Product / Process Change Notification (PCN)

PCN Number: PCN_UtLAN_20240625

Affected Series: WE-LAN

6. Dimension changes

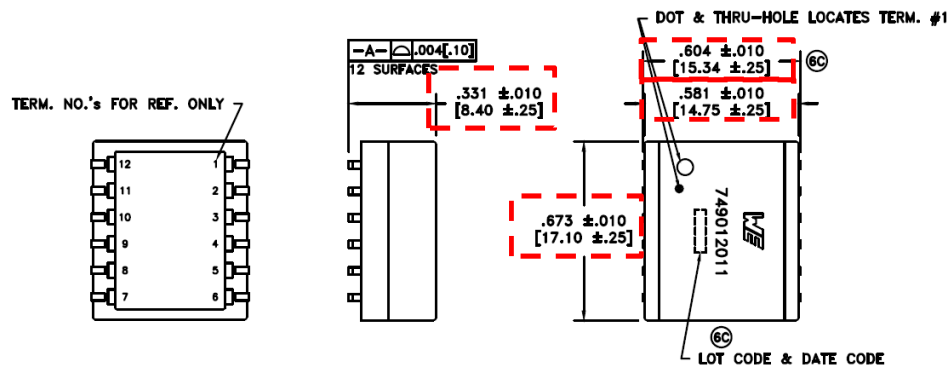
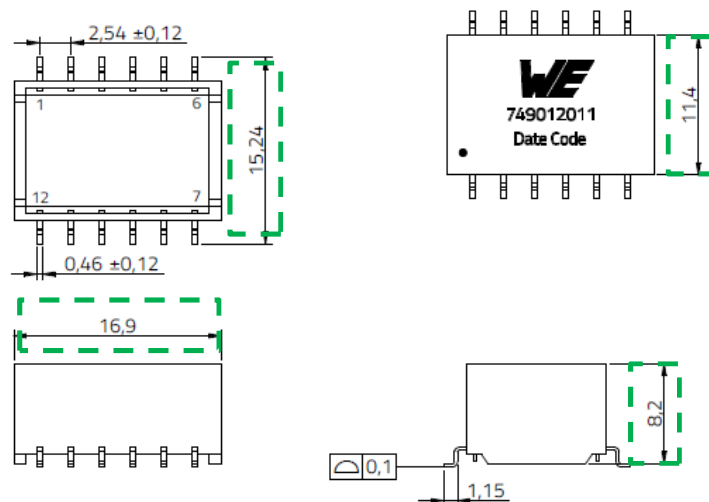
Affected part numbers: 749012011

Before change:

After change:
